**Martin's Point Bridge : Responses to Follow Up Questions
Received on the Final Request for Proposals (Final RFP),
December 9, 2011**

Subject: Falmouth-Portland, Martin's Point Bridge Design-Build Project (MaineDOT PIN 16731.00) – Responses to Follow Up Questions Received on the Final Request for Proposals (Final RFP)

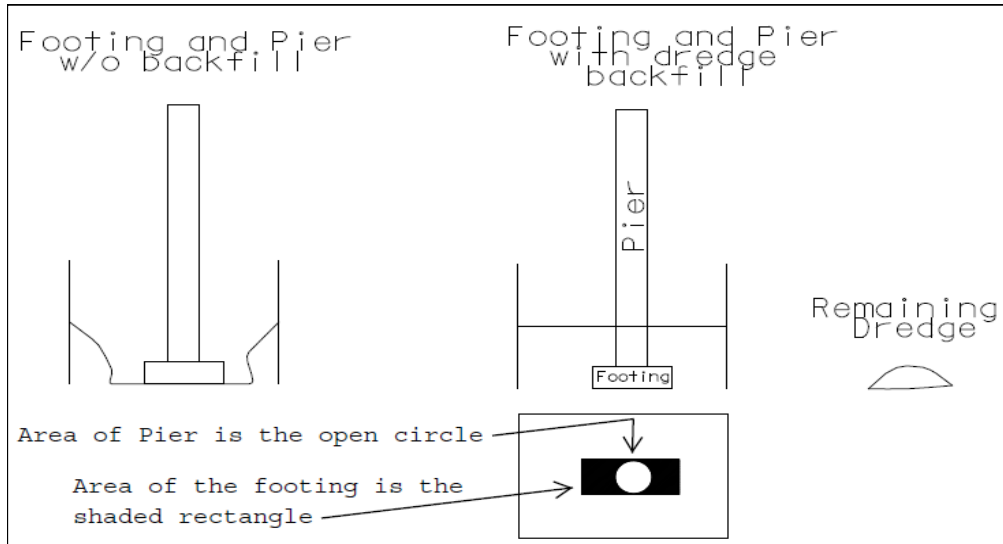
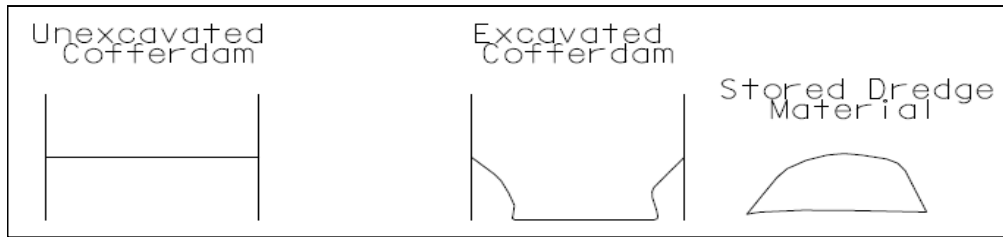
1. In follow up to the Nov. 02 Response to Question 2 (noted below): The answer seems to imply that only temporary fill is considered temporary wetland impact, but isn't the square foot ocean floor area of any new disturbance (i.e. excavation or dredging) outside a cofferdam considered a temporary wetland impact area whether in the intertidal zone or in non-tidal constantly submerged areas?

A. Please refer to the following figures which represent a hypothetical sequence of constructing a pier with a footing within a cofferdam for more explanation on determining temporary and permanent impacts.

- Area of the footing is considered temporary impact.
 - Area of pier is considered permanent impact.
 - Dredge material excavated and then put back in the excavated area (original dredge from excavation) does not count as impact area.
 - Remaining dredge material shall be properly disposed of in accordance with applicable regulations and the Maine DEP Solid Waste Rules Chapter 418.
 - New material, including riprap, that is placed in the excavated area is considered permanent impact.
-
- For excavation of material outside of a cofferdam, the square foot area is considered a temporary impact. If the material excavated is not put back, that material is considered dredge and must be properly disposed of in accordance with applicable regulations and the Maine DEP Solid Waste Rules Chapter 418.
